**Amendments to the Drawings**

**REMARKS**

Applicant has carefully reviewed the Examiner's Office Action dated July 14, 2005, in which the Examiner has requested minor corrections to the Specification because of informalities therein, and has objected to the drawings as failing to comply with 37 CFR 1.84(p)(5).

**FIG. 1**

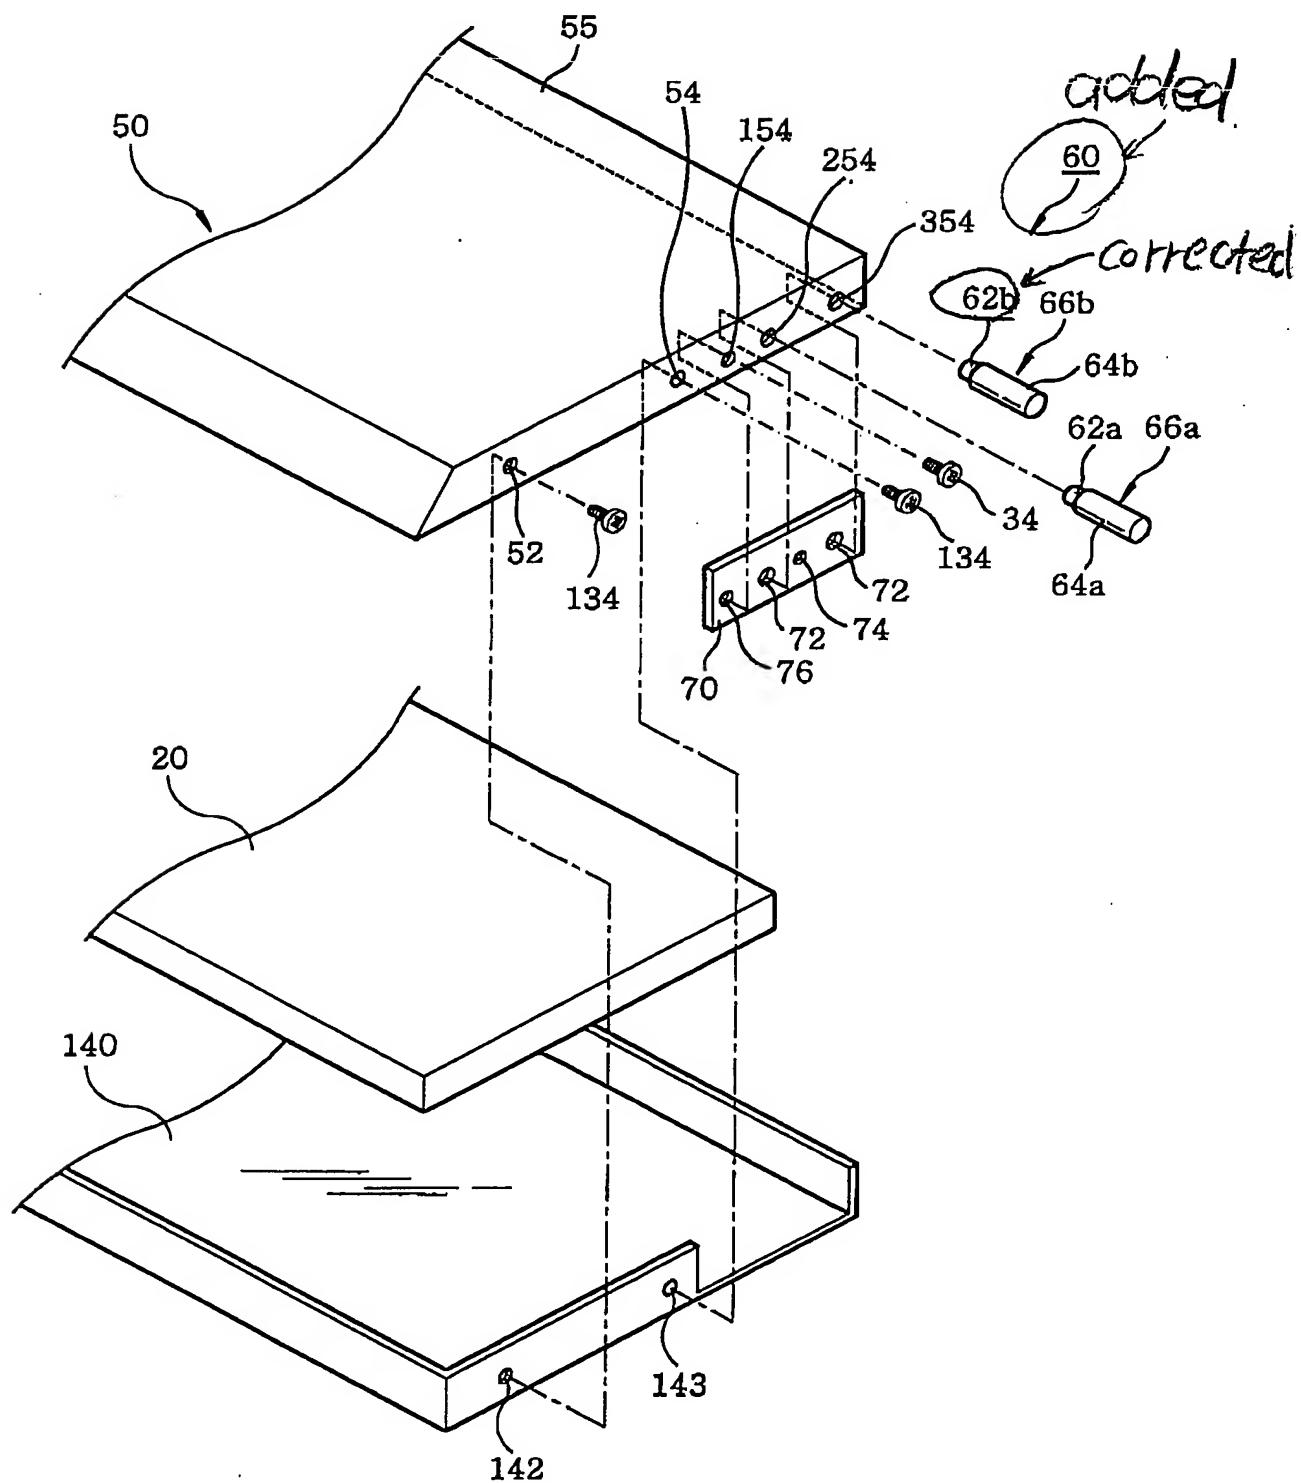
Figs. 1, 4 and 6 have been amended to overcome the Examiner's objections to the drawings without adding any new matter and in full compliance with the statutory requirements of 37 CFR 1.84(p)(5). A reference number 50 has added to Figure 1 and reference numbers 60 and 62b have been added to Figure 4. Also, reference numbers 156 and 158 have been added to Figure 6 to correspond with Figure 5. The insulated wall 16 is shown in Figure 3.

The attached sheets of drawings include changes to Figs. 1, 4 and 6.
